## ADDENDUM NO. 2

RE: Site Improvements and Renovations to Davis Hall  
Bridge Valley Community and Technical College  
Montgomery, West Virginia 25136  
Architect's Job No. 18046

**4** **EMERGENCY TOWER**  
 NO SCALE

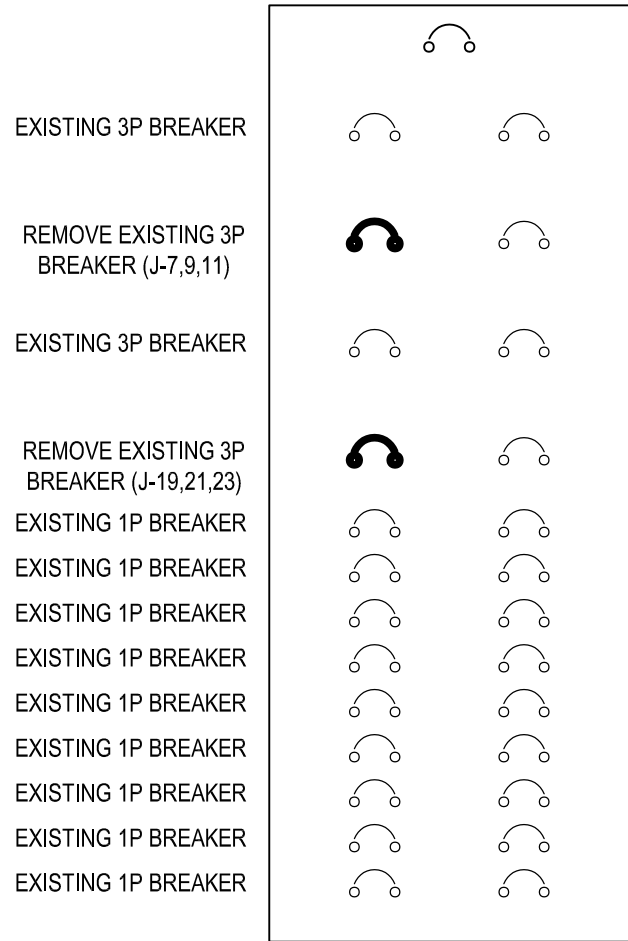
1. INSTALL CONDUITS THROUGH CONCRETE FOUNDATION UP THROUGH 4" DIAMETER HOLE IN THE TOWER BASE
2. INSTALL FOUR ANCHOR BOLTS IN THE CONCRETE AS DIRECTED BY THE MANUFACTURER'S WRITTEN INSTRUCTIONS.
3. ACQUIRE THE BOLT PATTERN FROM THE MANUFACTURER.

**ELECTRICAL RISER DIAGRAM**

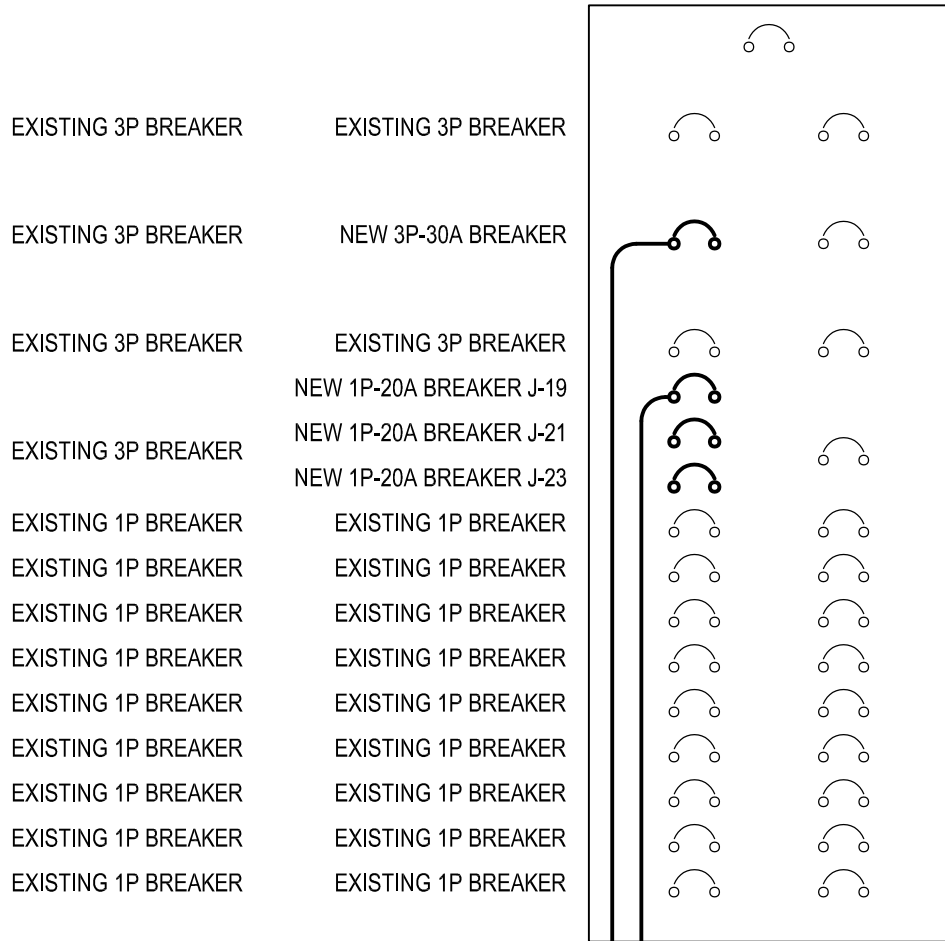
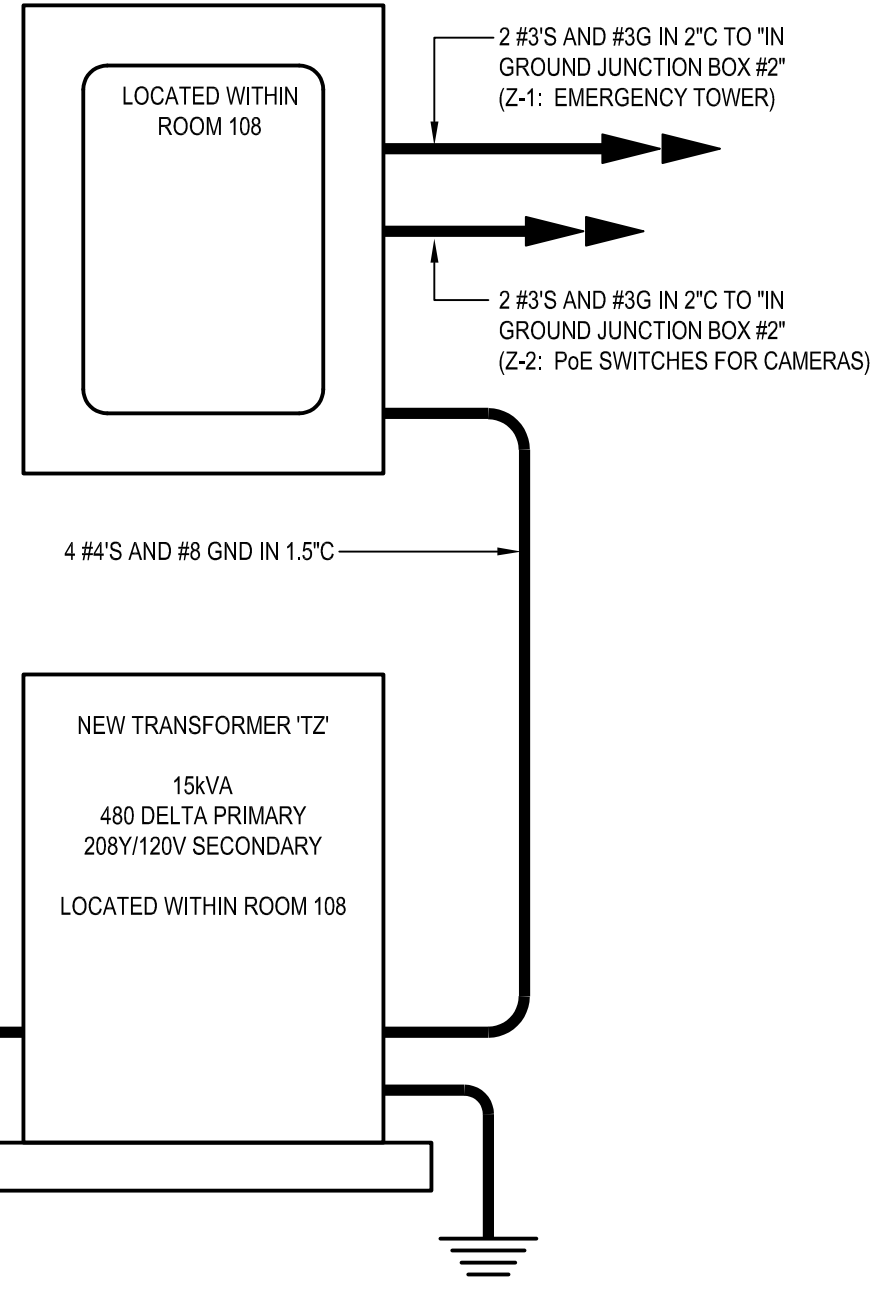
NEW 208Y/120V PANEL 'Z'  
LOCATED WITHIN ROOM 108

PANEL 'J' CKRT # 7,9,11  
3 #10'S AND #12 GND IN 1" C

2 #8'S AND #8 GND IN 2" C  
TO SITE LIGHTING SEE  
E141 FOR CONTINUATION

**1 SUMP PUMP DETAIL**

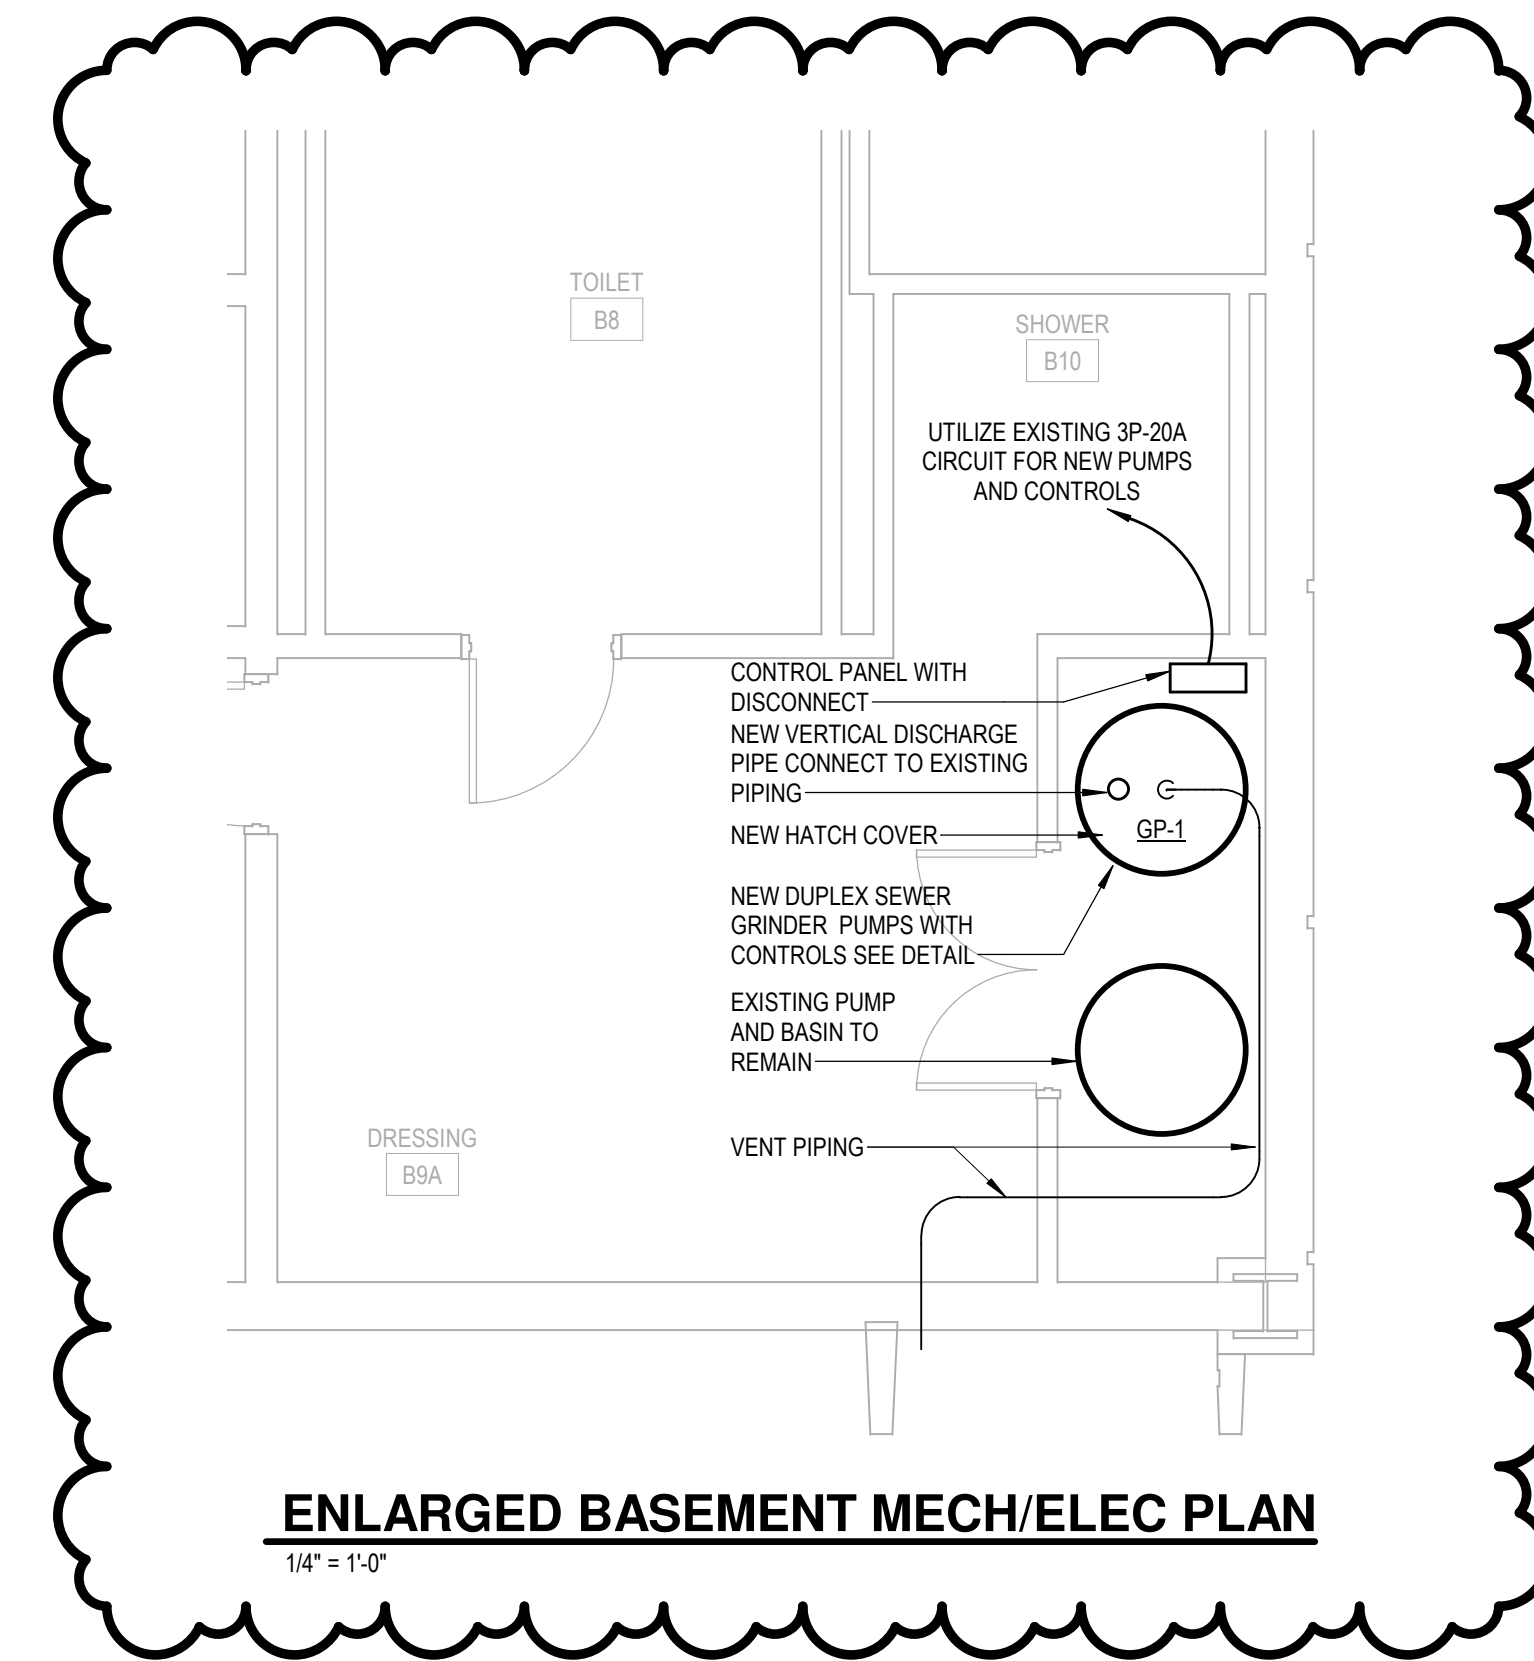
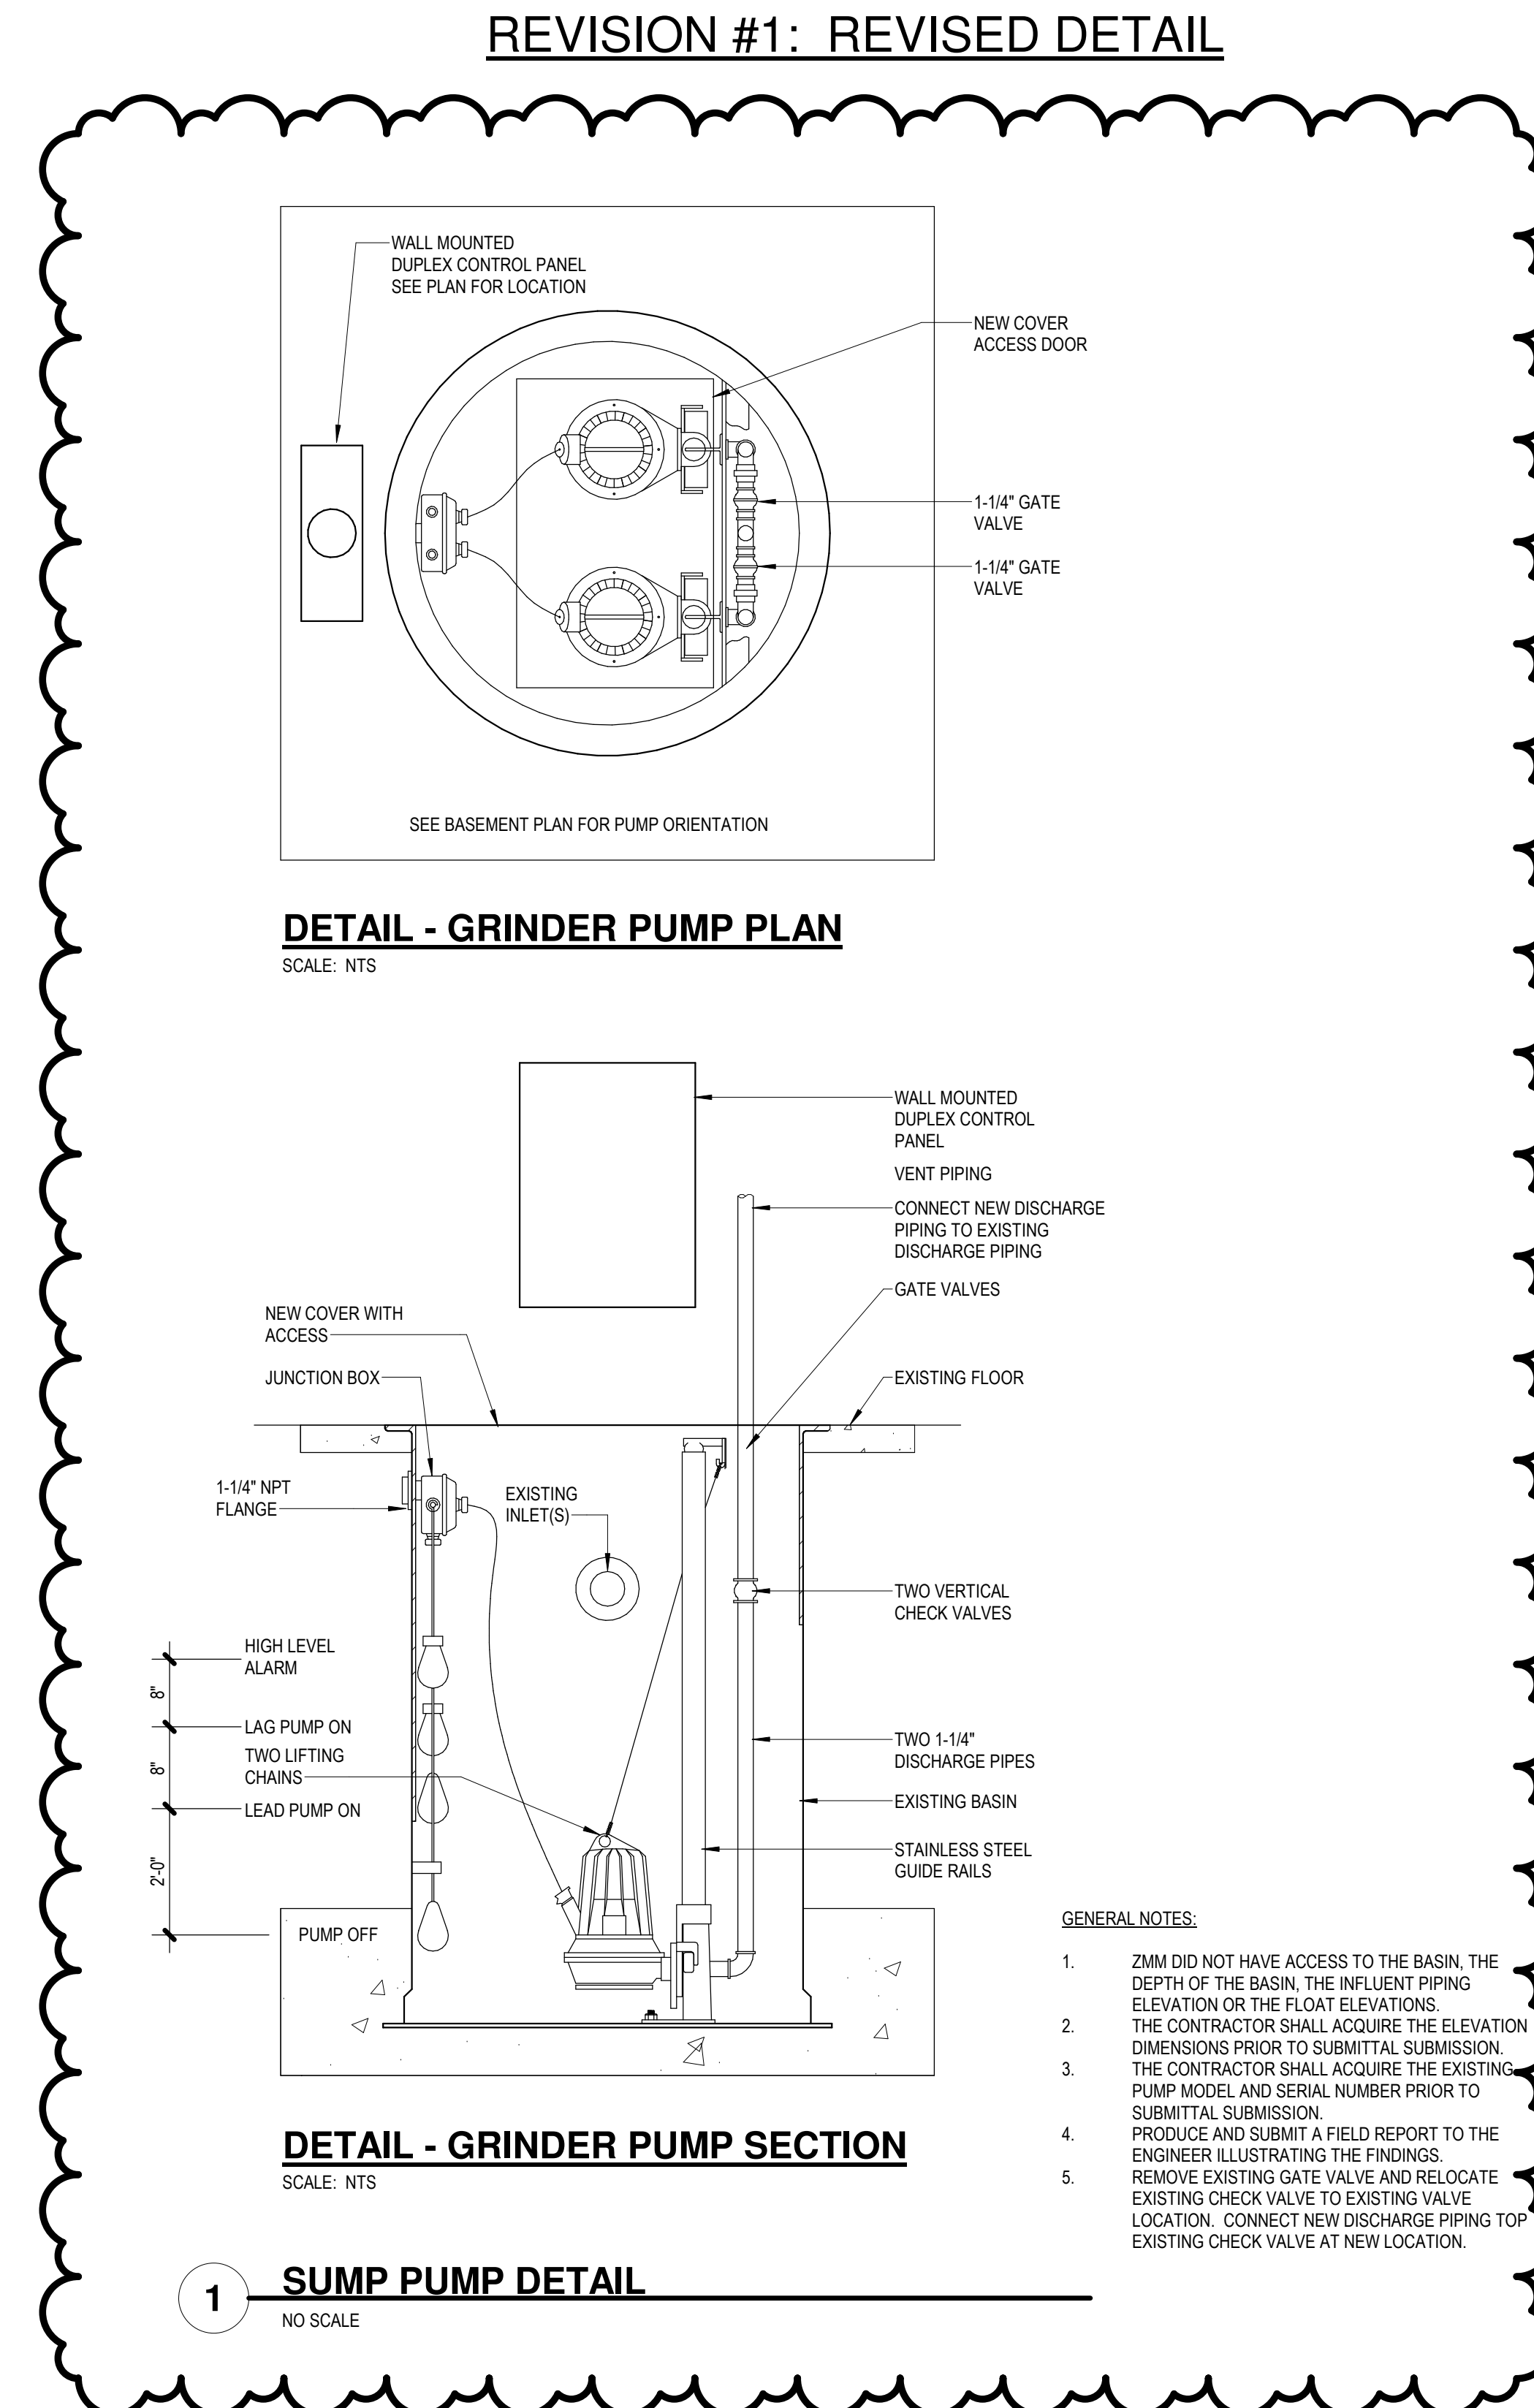
**REVISION #1: REVISED SCHEDULE**

**REVISION #1: ENLARGED PLAN**

- GENERAL NOTES:**
- ZMM DID NOT HAVE ACCESS TO THE BASIN, THE DEPTH OF THE BASIN, THE INFLUENT PIPING ELEVATION OR THE FLOAT ELEVATIONS. THE CONTRACTOR SHALL ACQUIRE THE ELEVATION DIMENSIONS PRIOR TO SUBMITTAL SUBMISSION.
  - THE CONTRACTOR SHALL ACQUIRE THE EXISTING PUMP MODEL AND SERIAL NUMBER PRIOR TO SUBMITTAL SUBMISSION.
  - PRODUCE AND SUBMIT A FIELD REPORT TO THE ENGINEER ILLUSTRATING THE FINDINGS.
  - REMOVE EXISTING GATE VALVE AND RELOCATE EXISTING CHECK VALVE TO EXISTING VALVE LOCATION. CONNECT NEW DISCHARGE PIPING TOP EXISTING CHECK VALVE AT NEW LOCATION.
